## D80D0WQ ERASER v1.0 ERRATA SHEET

Figure 1. Resistors preparation

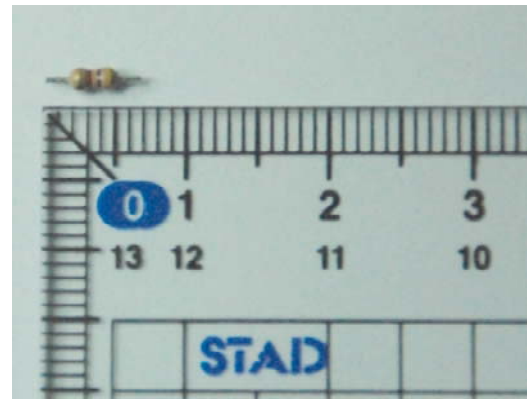
Prepare 3 resistors: make it 7 mm length from both sides. Resistors from the right side must be solder to ATMEGA16 – pins numbers: 16; 17; 18. Prepare insulated wire ~35 - 38 mm. Resistors from the left side must be solder together then across the board to capacitor with nominal 0.1mF according to picture 2. Then apply the glue to the joints.

Figure 2. Wire across the boards then apply the glue to the joins

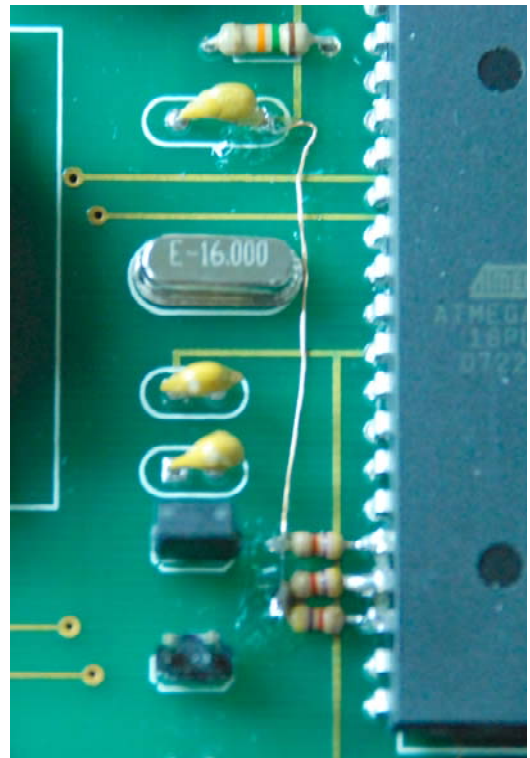
This improvement helps to avoid problems during entering to the test mode.
